Department of
State Development, Manufacturing, Infrastructure and Planning

Our reference: 1905-10997 SRA
Your reference: MCUI/11/2019

Changed referral agency response—with conditions
(Given under section 28 of the *Development Assessment Rules*)

Development permit	Material Change of Use for Tourist attraction and Market

1 - SITE PLAN
1 : 625

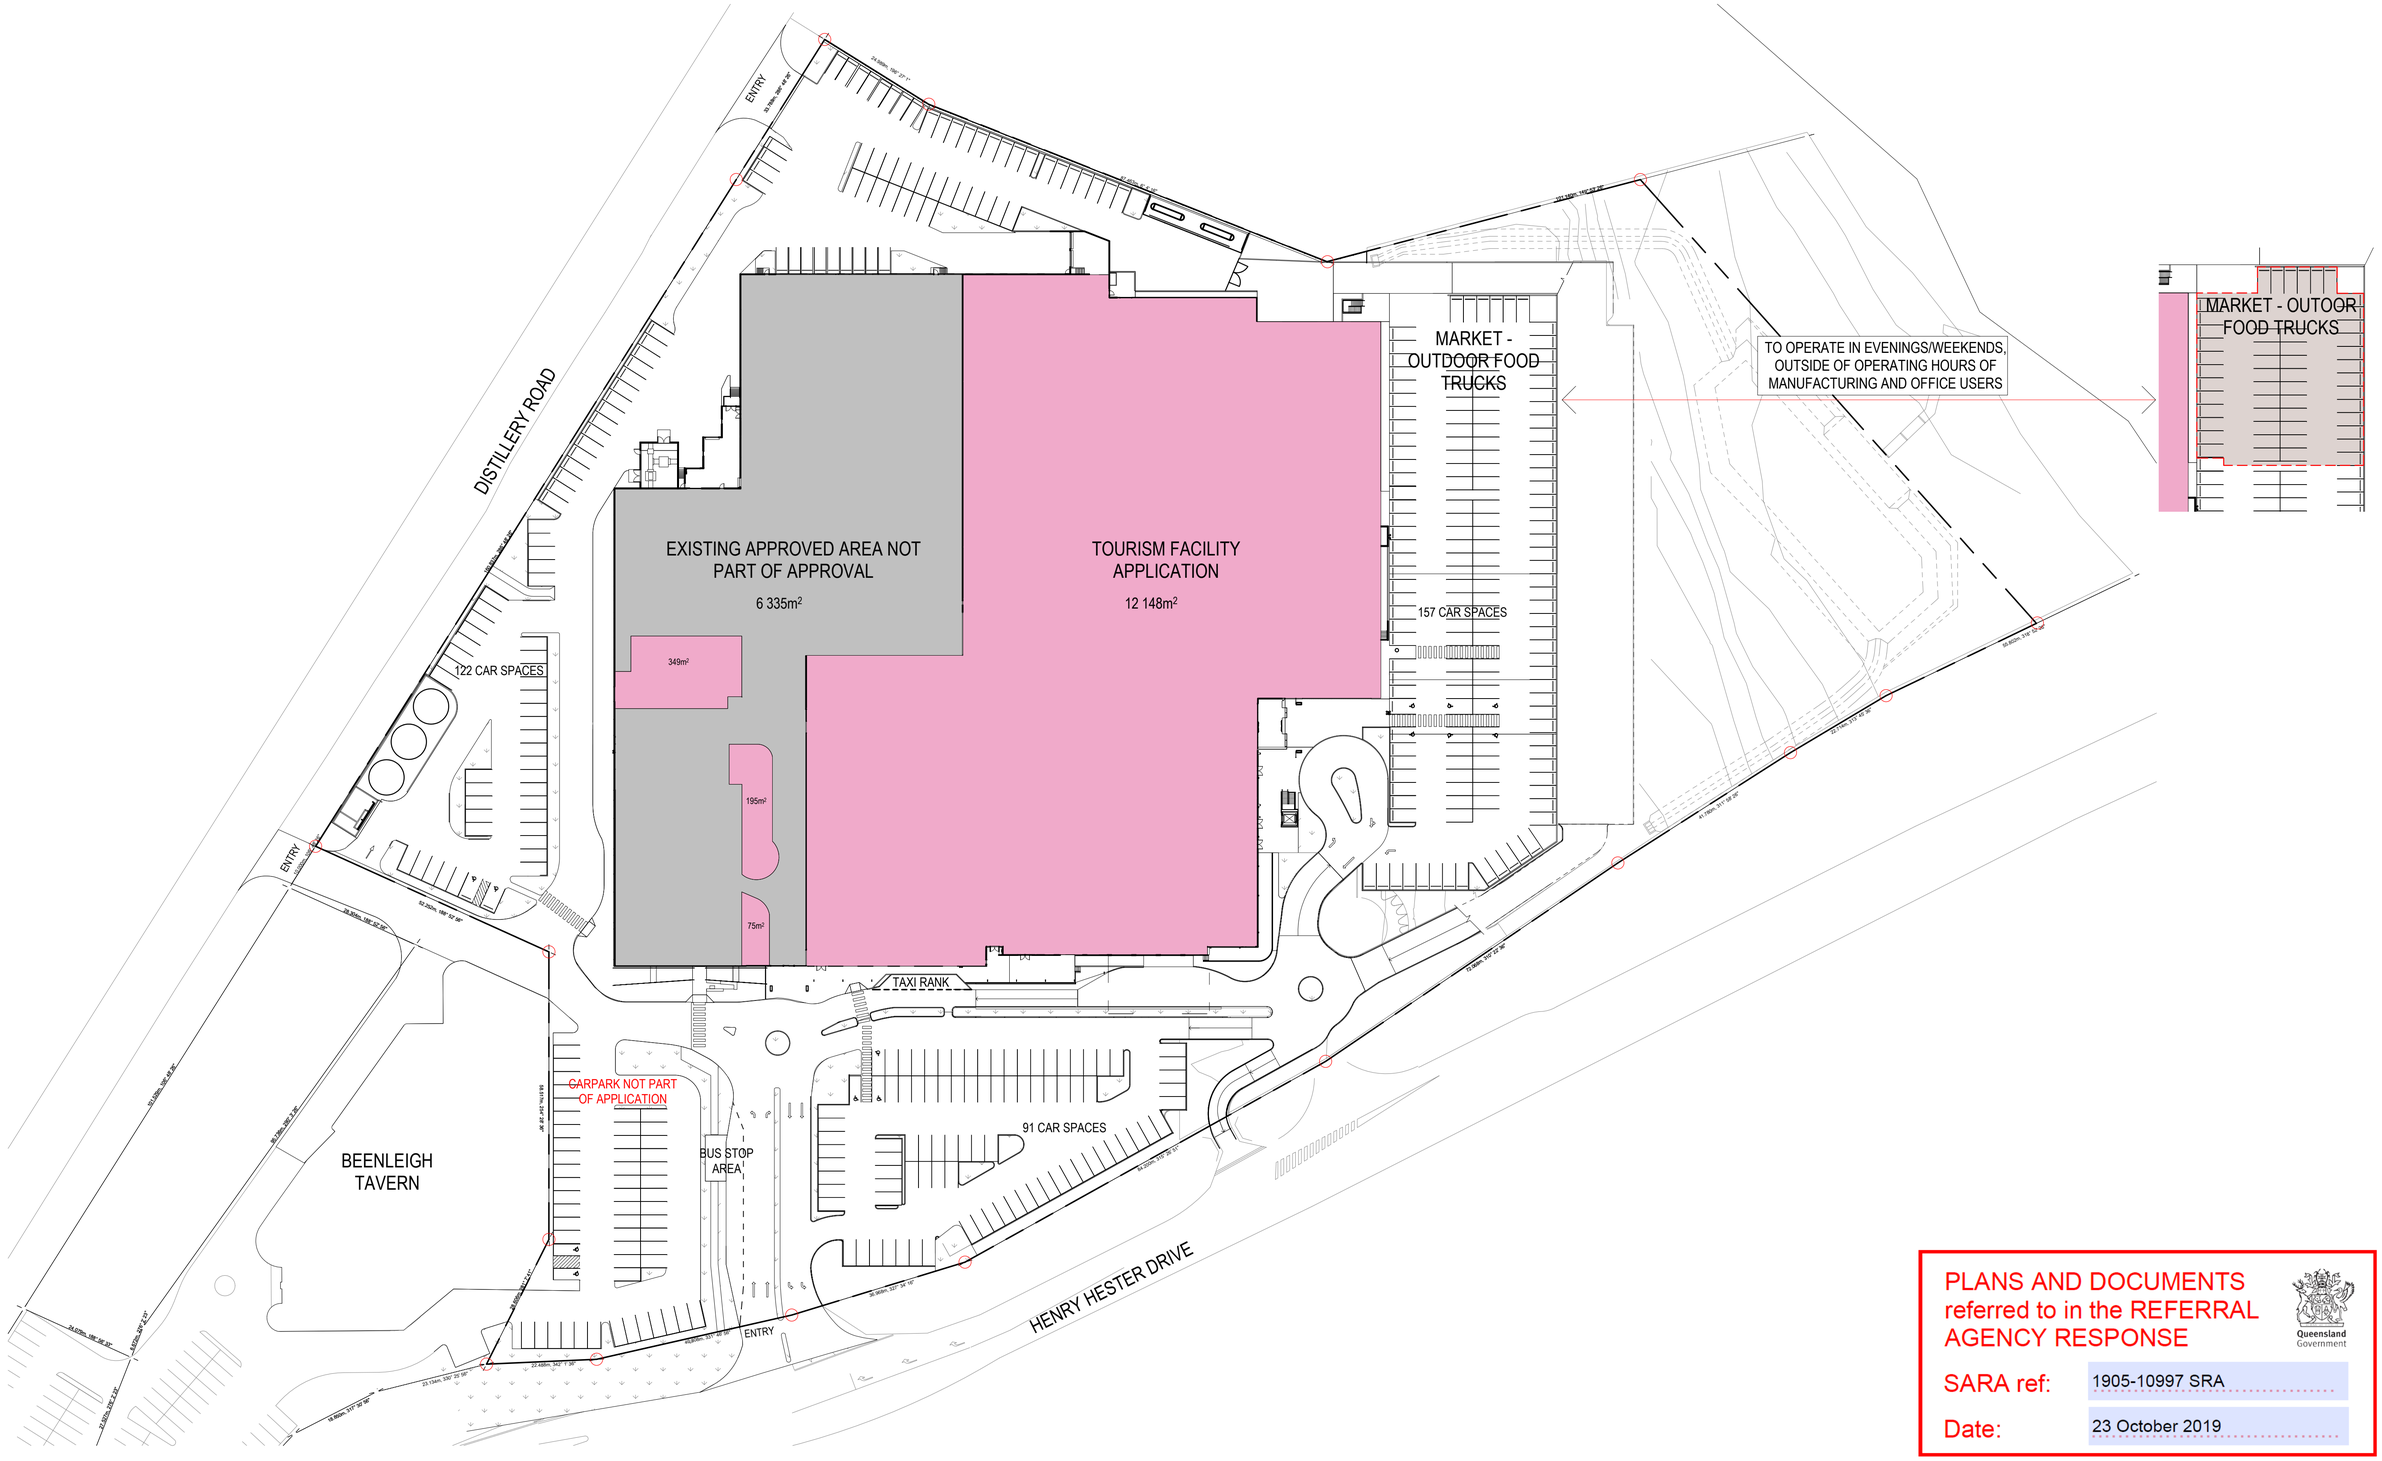
1.	The development must provide an indented private bus/coach setdown (3m minimum width, 25m minimum length plus entry and exit tapers), hardstand/access for passengers and a paved pedestrian footpath and pedestrian crossing between the 'bus stop area' and 'tourist entry' generally in accordance with the Site Plan, prepared by Medhurst Architects, dated January 2019, reference 4-030 and revision 1.	(a) and (b) Prior to the commencement of use for stage 1 and to be maintained at all times

2.	(a) The applicant must provide a dedicated taxi rank parallel to the kerb at the location shown on Site Plan, prepared by Medhurst Architects, dated January 2019, reference 4-030 and revision 1. (b) The dedicated taxi rank must be designed and constructed to include the following: • a minimum of two (2) taxi parking bays in accordance with AS2890.5 - Parking facilities, Part 5: On-street parking; • of the taxi bays provided, at least one (1) is to be of a length and width suitable for use by people with disabilities in accordance with AS1428.1 - Design for access and mobility and AS2890.6 – Parking Facilities, Part 6: Off-street parking for people with disabilities; • two taxi zone signs R5-21, placed at either end of the dedicated taxi rank, and taxi zone line marking in accordance with AS1742.11 – Manual of uniform traffic control devices, Part 11: Parking controls; • lighting in accordance with AS/NZS 1158.3.1 – Lighting for Roads and Public Spaces, Part 3.1: Pedestrian Area (Category P) Lighting – Performance and Design Requirements; • accessibility in accordance with the Disability Standards for Accessible Public Transport 2002 made under subsection 31(1) of the *Disability Discrimination Act 1992* and the Department of Transport and Main Road's *Public Transport Infrastructure Manual 2015;* and • a paved pathway between the taxi rank and the 'tourist entry' generally in accordance with the Site Plan, prepared by Medhurst Architects, dated January 2019, reference 4-030 and revision 1. (c) RPEQ certification must be provided to the Program Delivery and Operations Unit, South Coast Region	(a) & (b) Prior to the commencement of use for Stage 1 and to be maintained at all times (c) Prior to the commencement of use for Stage 1
